Planning Commission Meeting Agenda

- A. Community Development: Variance No. 0016-24, a request to deviate from the standards of the Hanford Municipal Code Section 17.60.070(B), in order to locate a restaurant with a drive-thru pick-up window, Robertito's, on a parcel with a size less than one-half ($\frac{1}{2}$) acre in the MX-C Corridor Mixed Use zone district. The project is located at the northwest corner of Silverado Street and S. 11th Avenue (APN 012-370-001).

PROJECT: Site Plan Review No. SPR0086-24

PLANNING DIVISION
SITE PLAN REVIEW COMMENTS

Exhibit A
Site Plan

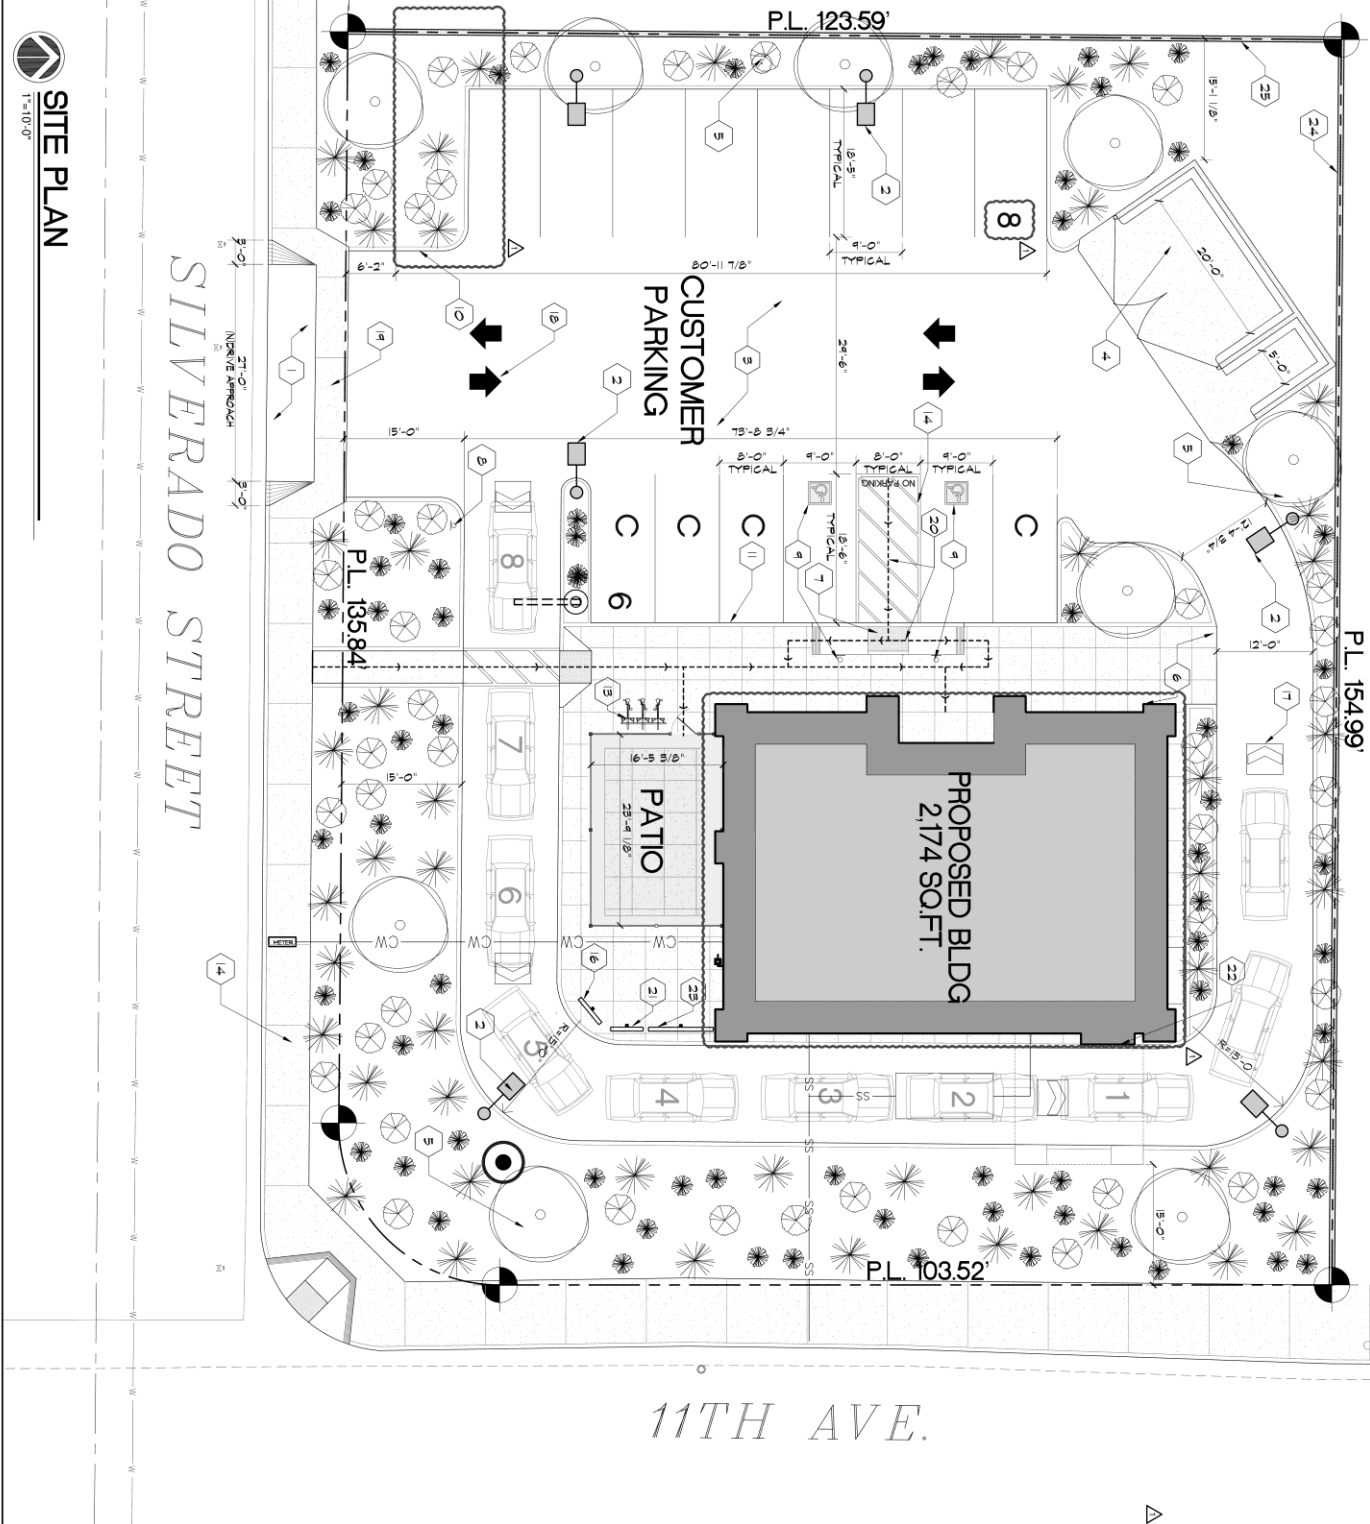
- ☒ That all approved proposals of the applicant be conditions of development, if not mentioned herein.
- ☒ That the site be developed according to the approved site plan, titled Site Plan Review No. 0086-24 with minor modifications to be approved by the Community Development Department.

- ☒ That in all mixed use zone districts, not less than five percent (5%) of the interior square footage of a parking area shall be landscaped with trees and other plant materials suitable for ornamentation. Parking areas are to have one (1) tree placed at every four (4) lineal parking spaces. Landscaped areas shall be distributed throughout the parking area and peripheral areas to the extent practical in consideration of the size and design of the parking area. Parking lots developed next to a street shall provide a landscape buffer between the street and the parking lot of at least ten (10) feet.

- ☒ That entrances and exits to parking lots and other parking facilities shall be provided only at locations approved by the Site Plan Review Committee.

General Requirements:

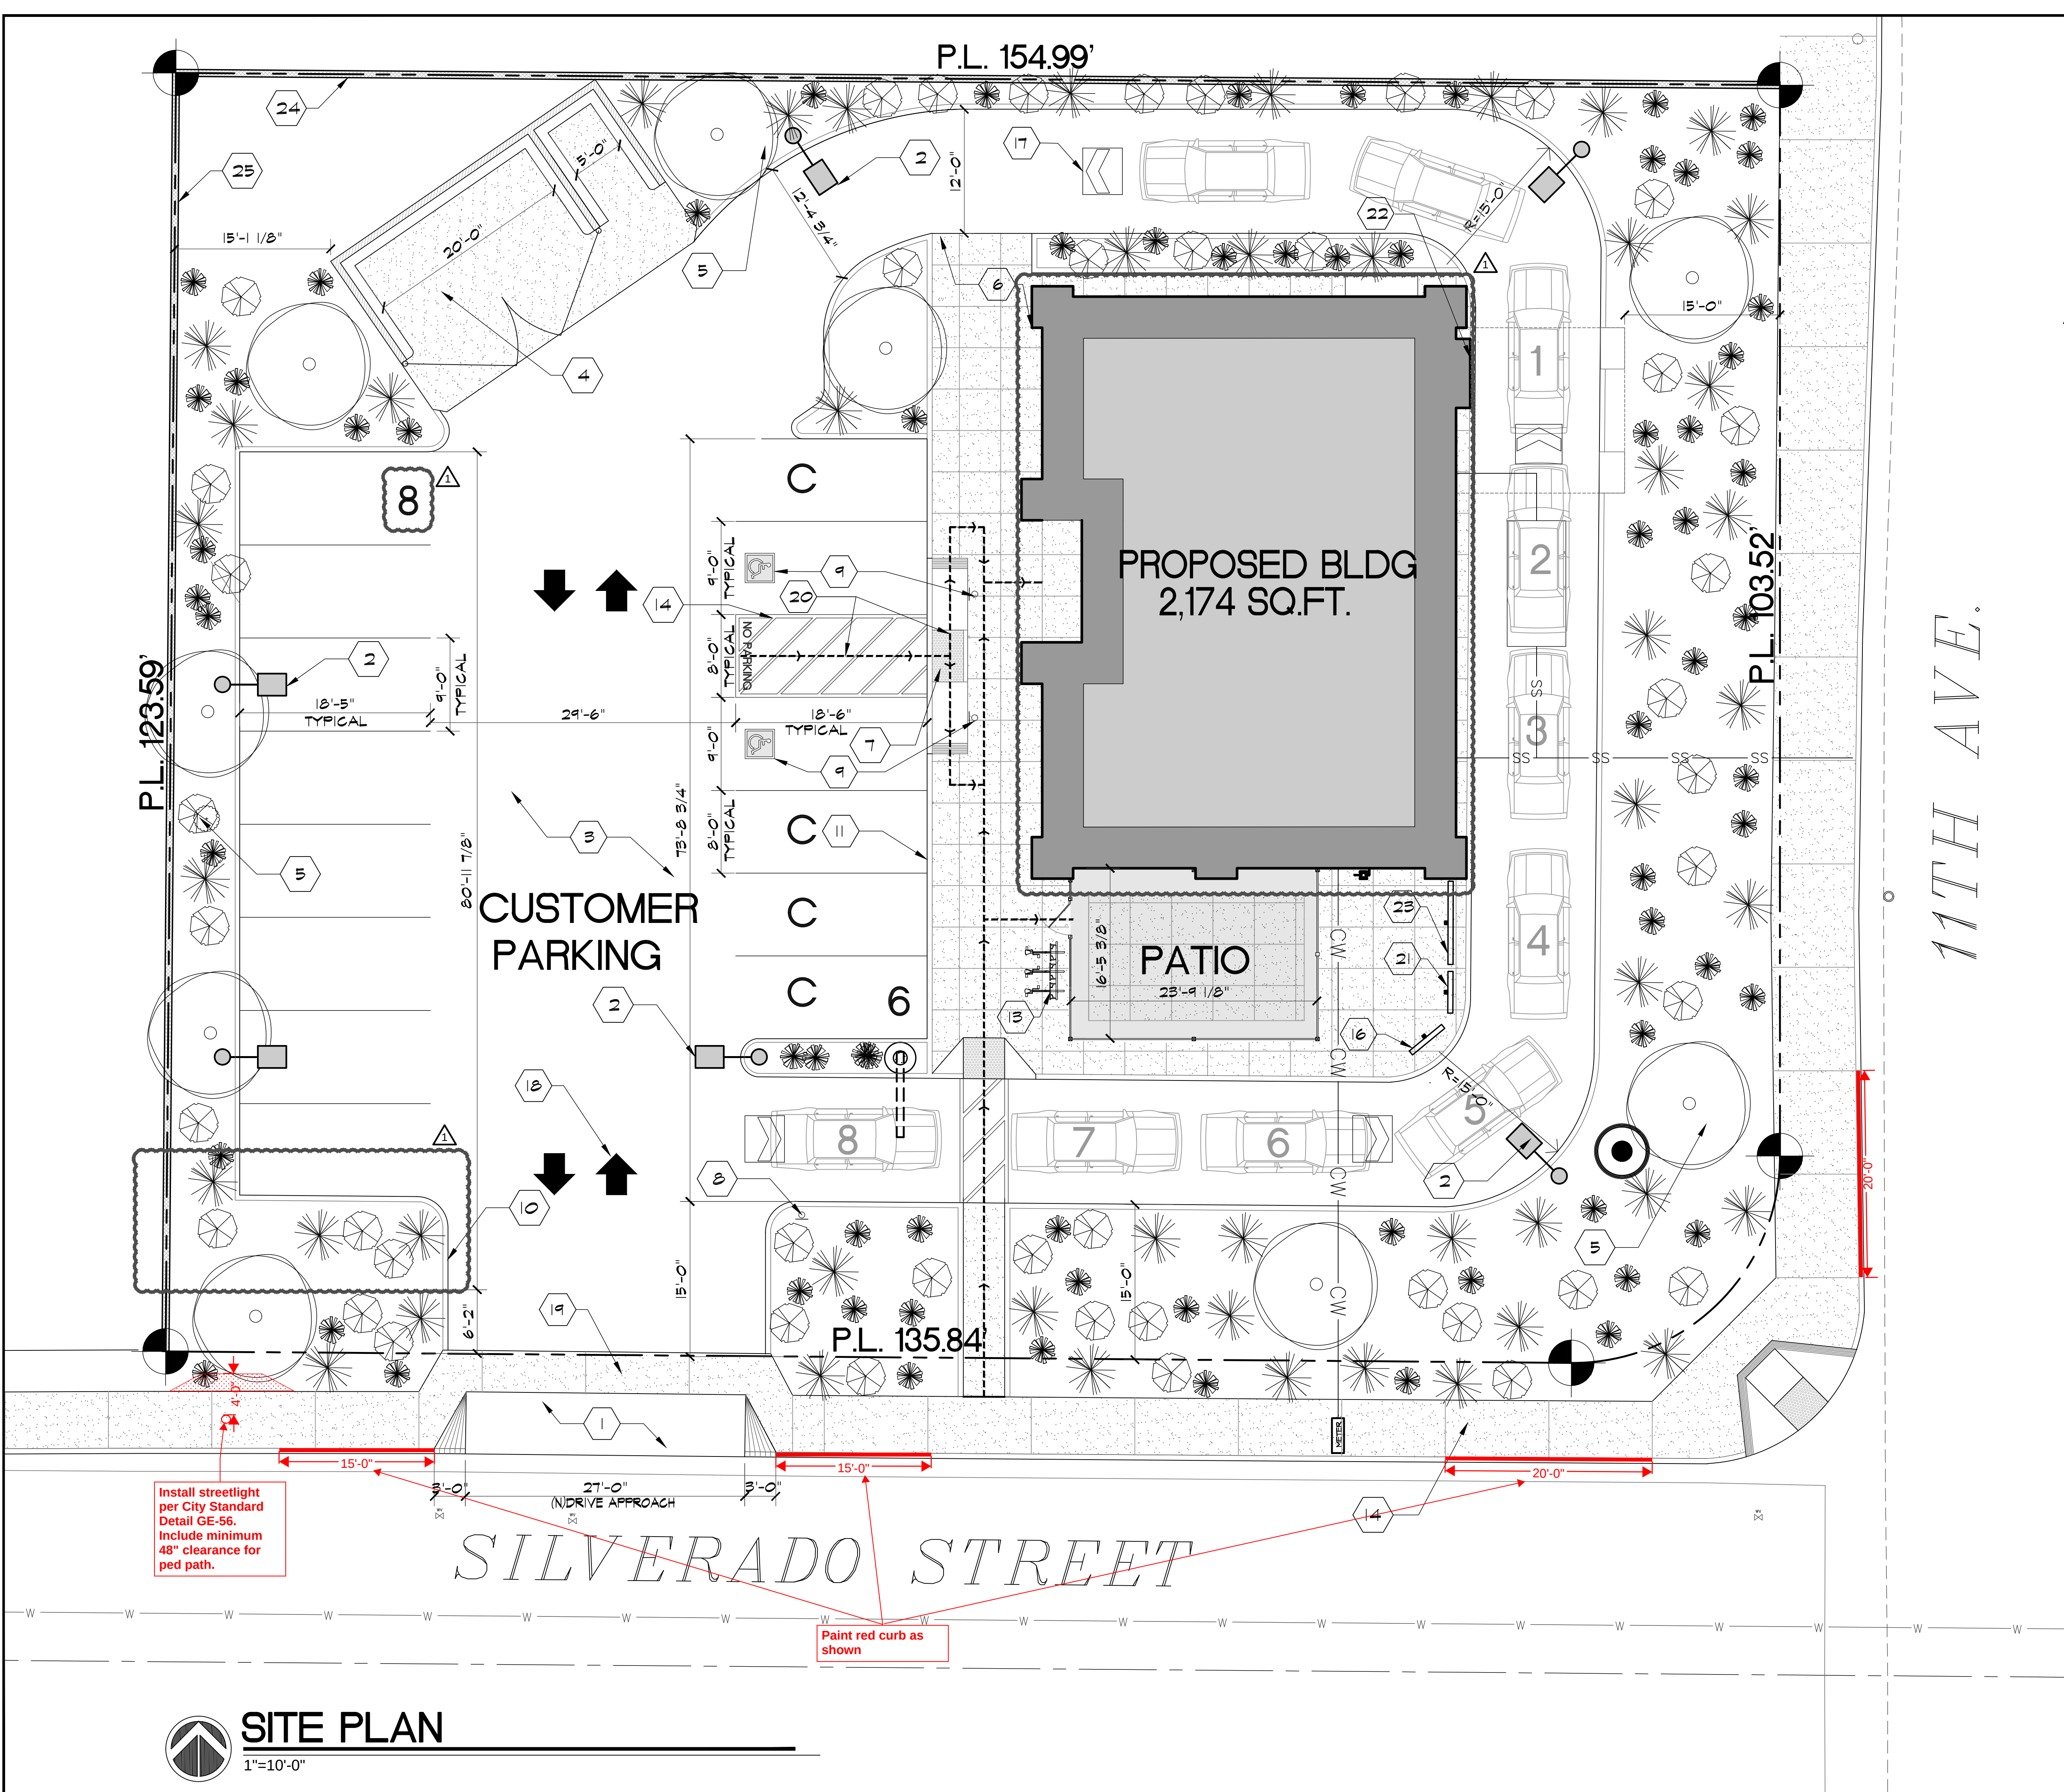
1. That a minimum 10' X 20' inside clear dimension masonry block refuse enclosure with 6' high perimeter walls shall be constructed in accordance with City Std. GE-41, modified to include installation of 12" X 12" interior concrete curbs and 10' concrete apron. If enclosure will be used to service restaurants, then a separate grease bin container area shall be constructed and hot/cold water shall be installed in accordance with City Standard GE-41. The refuse enclosure shall have gates of chain-link fencing with earth-tone color vinyl slats or other approved gate material. The enclosure shall be architecturally compatible with surrounding buildings, and the location of the enclosure shall be approved by both the Public Works and Community Development Departments.

2. It is the responsibility of the Applicant to ensure that the Refuse Division has an unobstructed clear path of access for servicing and collecting the refuse bins. Refuse hours of operation for commercial properties are 5:00 A.M. to 1:30 P.M.

General Requirements:

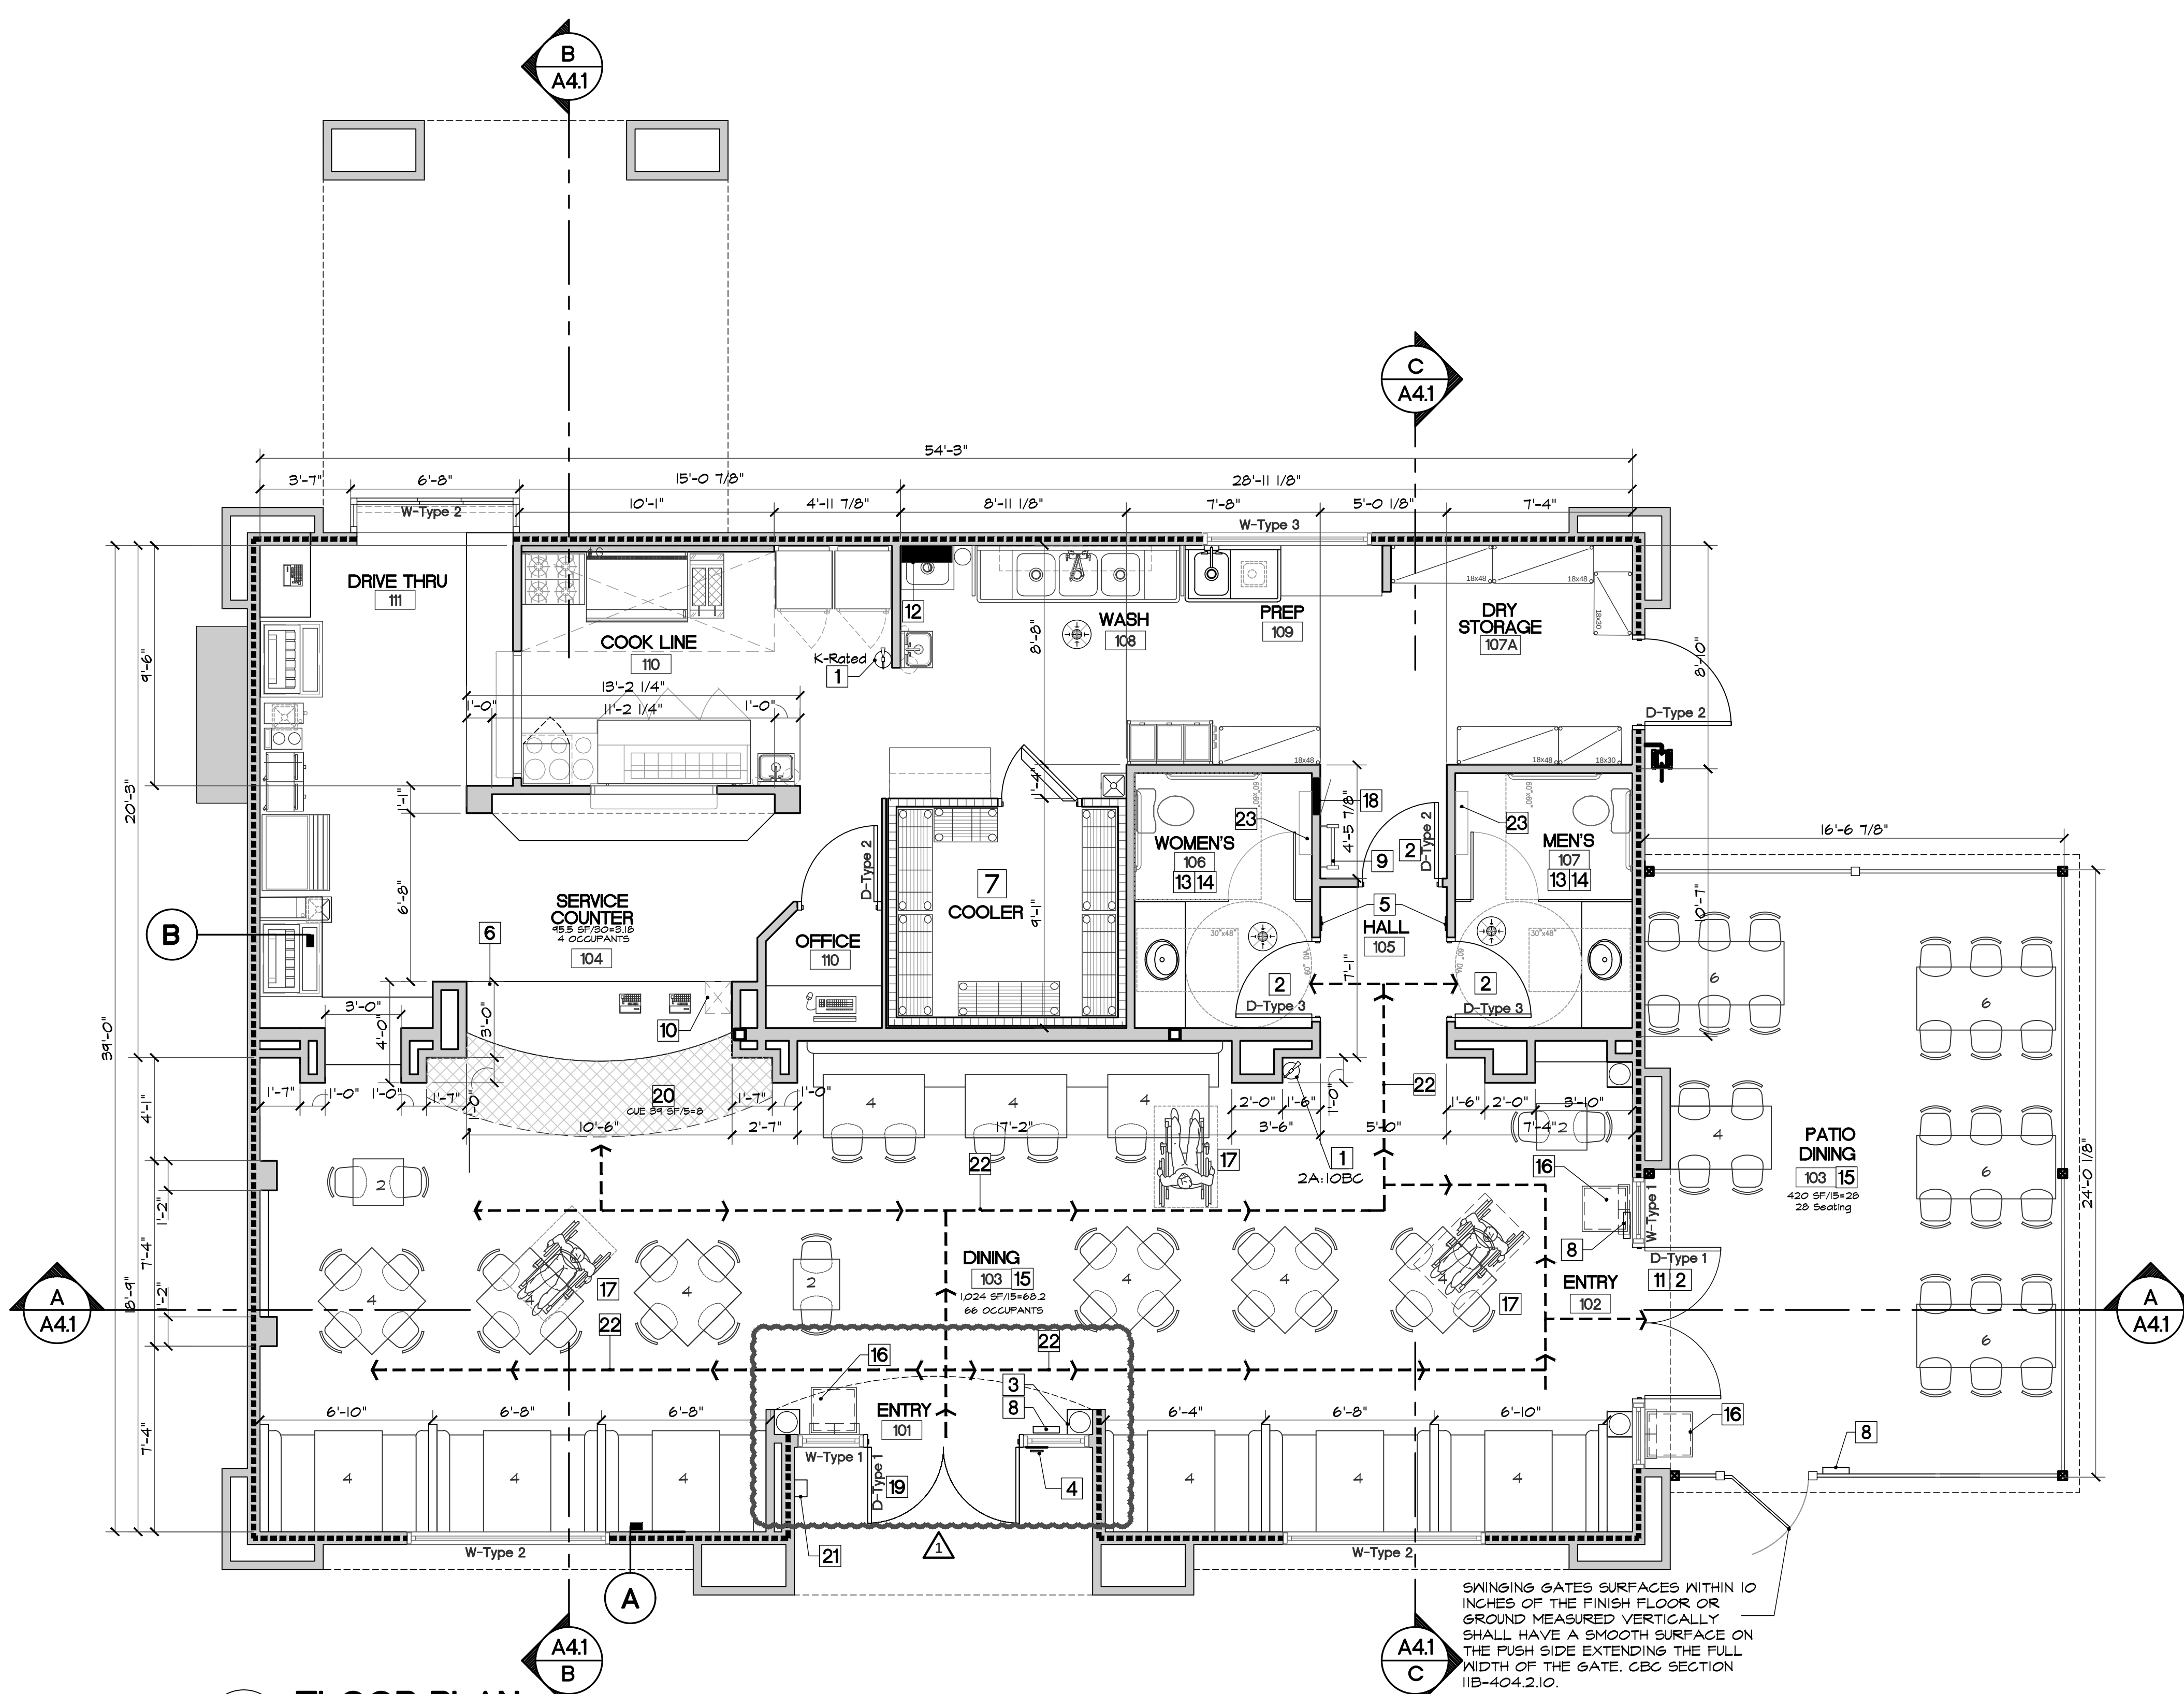
1. That a minimum 10' X 20' inside clear dimension masonry block refuse enclosure with 6' high perimeter walls shall be constructed in accordance with City Std. GE-41, modified to include installation of 12" X 12" interior concrete curbs and 10' concrete apron. If enclosure will be used to service restaurants, then a separate grease bin container area shall be constructed and hot/cold water shall be installed in accordance with City Standard GE-41. The refuse enclosure shall have gates of chain-link fencing with earth-tone color vinyl slats or other approved gate material. The enclosure shall be architecturally compatible with surrounding buildings, and the location of the enclosure shall be approved by both the Public Works and Community Development Departments.

2. It is the responsibility of the Applicant to ensure that the Refuse Division has an unobstructed clear path of access for servicing and collecting the refuse bins. Refuse hours of operation for commercial properties are 5:00 A.M. to 1:30 P.M.
